AURA DEVELOPMENT – PRECINCT 18 AURA LAKES

Road Traffic Noise Assessment

Report
217401.0141.R02V03

Table 1.1: SARA Information Request (December 2023) and Summary Response

Figure 5.1: Modelled Road Sections

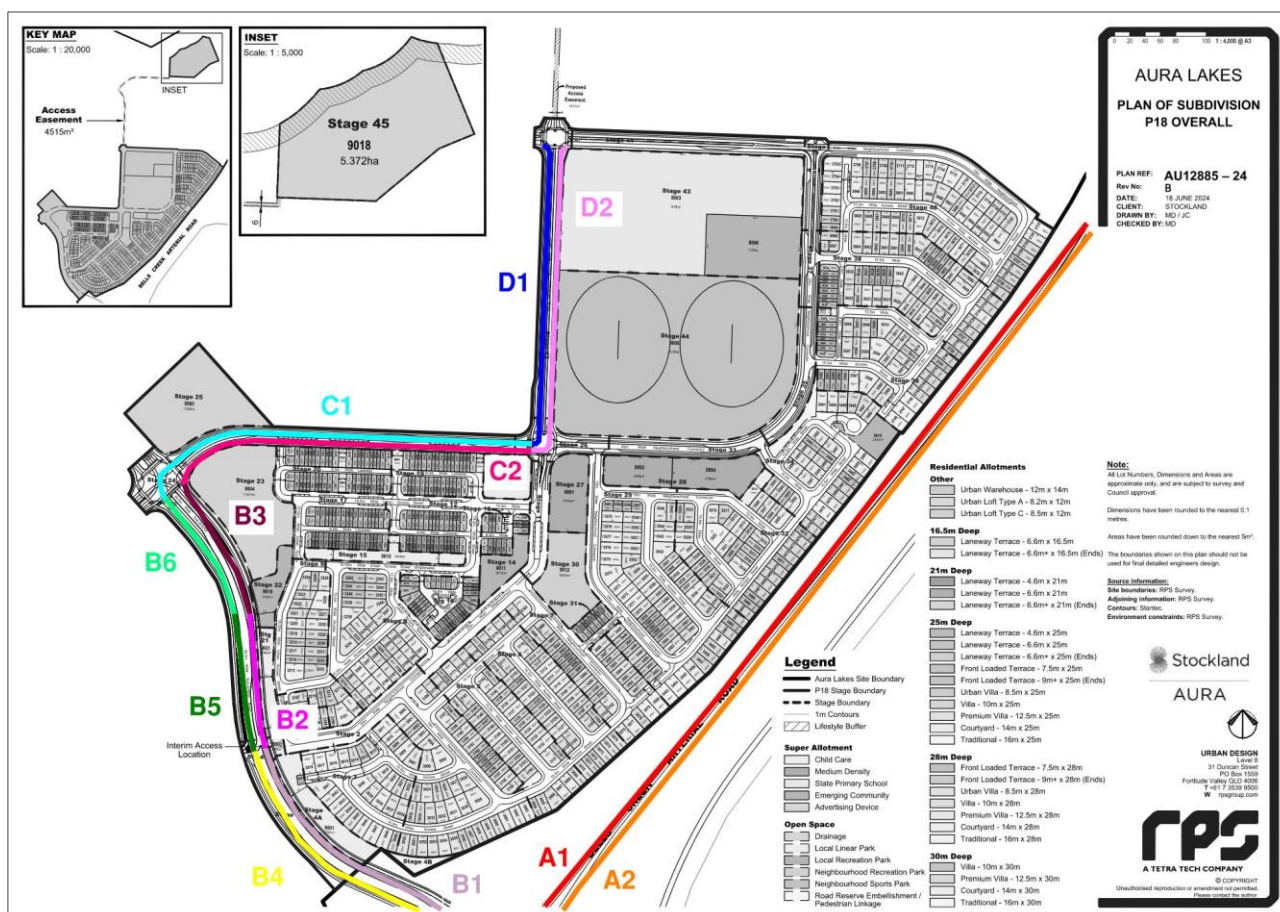
Item 2e Provide a response to DTMR Acoustic Assessment Item 4. Segment A3 and A4 in Figure 5.1 is only the traffic volume of the interchange ramp (based on 2031 traffic model). The ramp infrastructure would be located much closer to the P18 boundary. Remodel the interchange based on a schematic interchange design and include the traffic volume of the interchange itself. Provide spot levels for the schematic interchange design.	In relation to TMR Item 4, the road alignment and heights are as per the Stantec drawings provided in Appendix F.

Figure
C.4

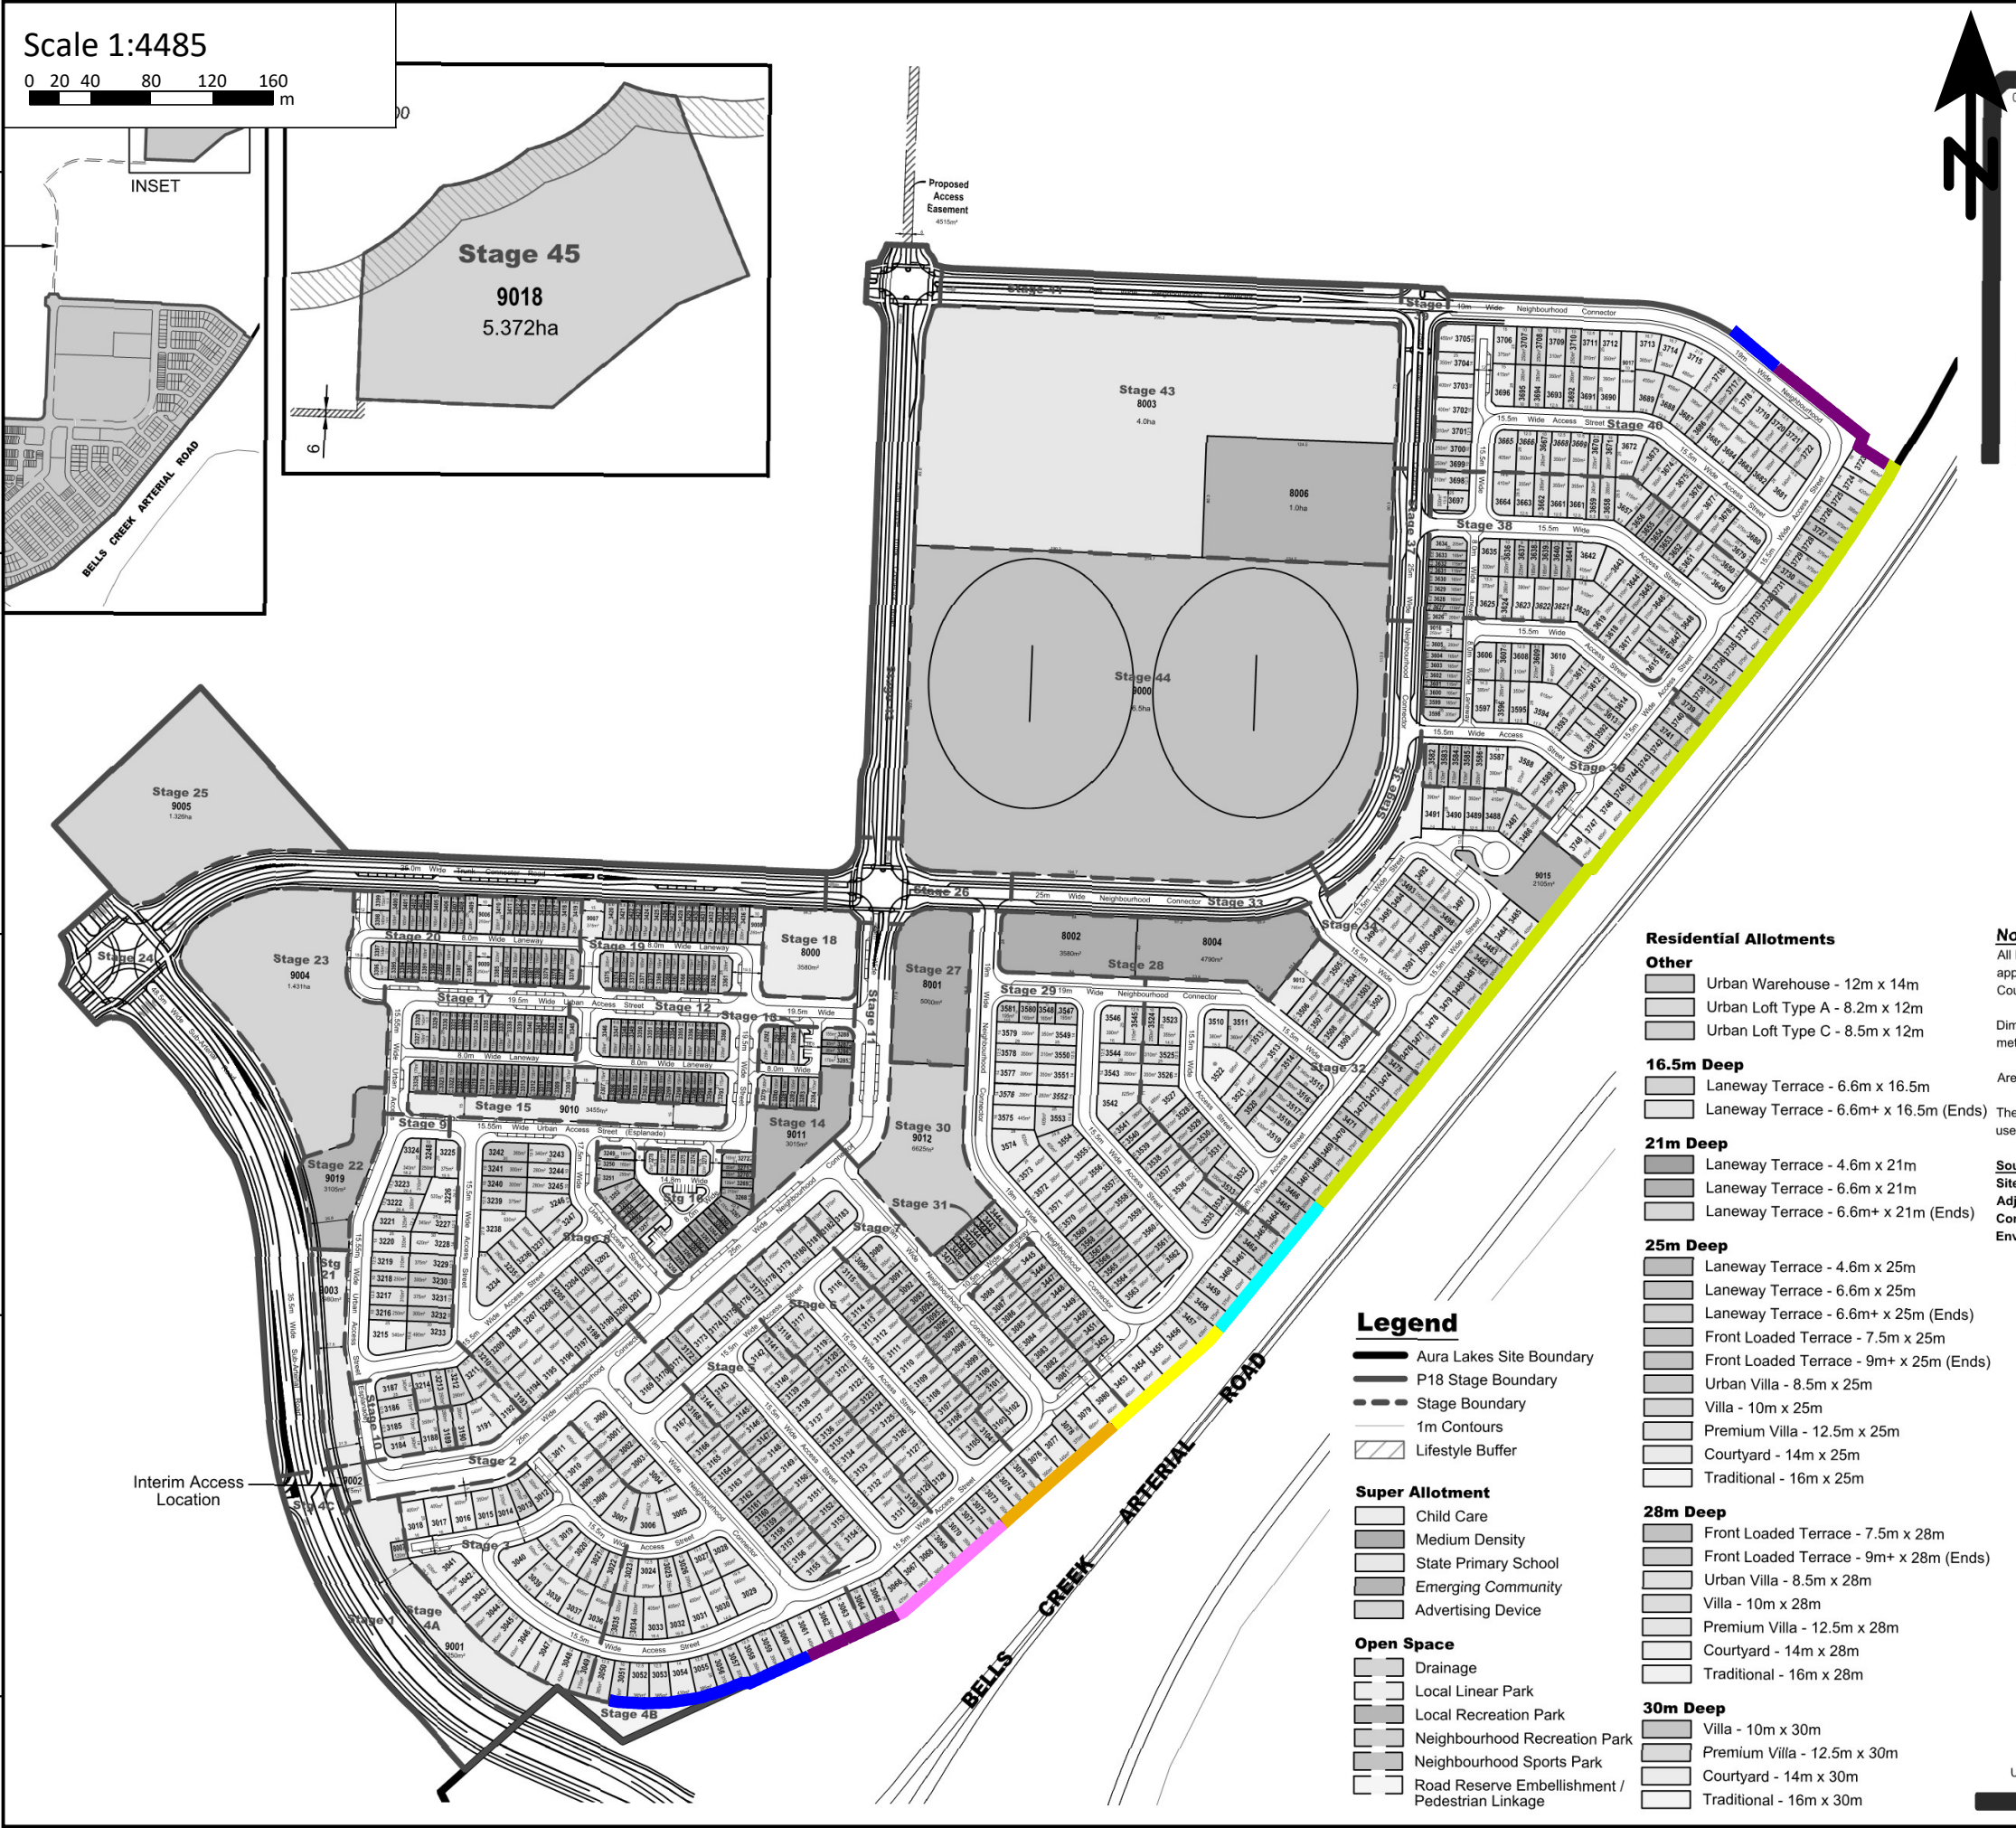
Item 3 Provide a separate plan with appropriate chainage and section / details for all required acoustic barriers and heights (to top of wall / RL).	Figure C4 presents the barrier relative height details. The heights are relative to the digital terrain model provided (Appendix F). Further barrier details are provided separately by Stantec.
